650cc

PrintArea

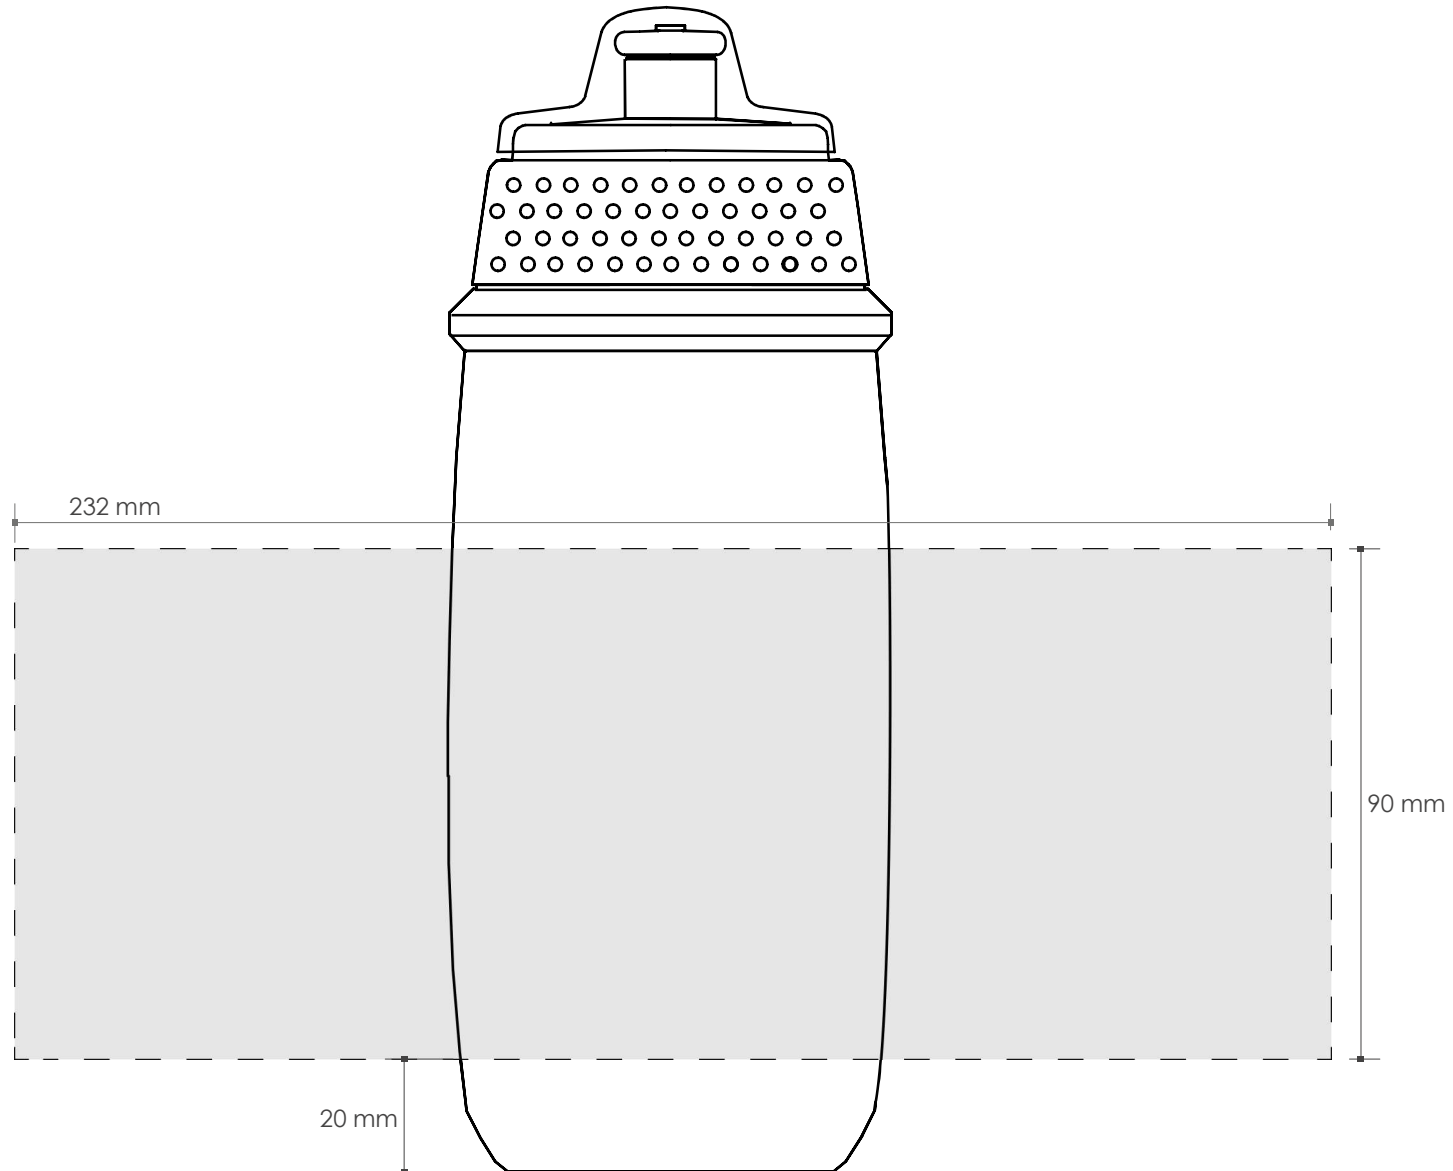
The impression can not close on the circumference of the bottle:
it's necessary to consider a non-printable area (approx. 0,8 cm width)
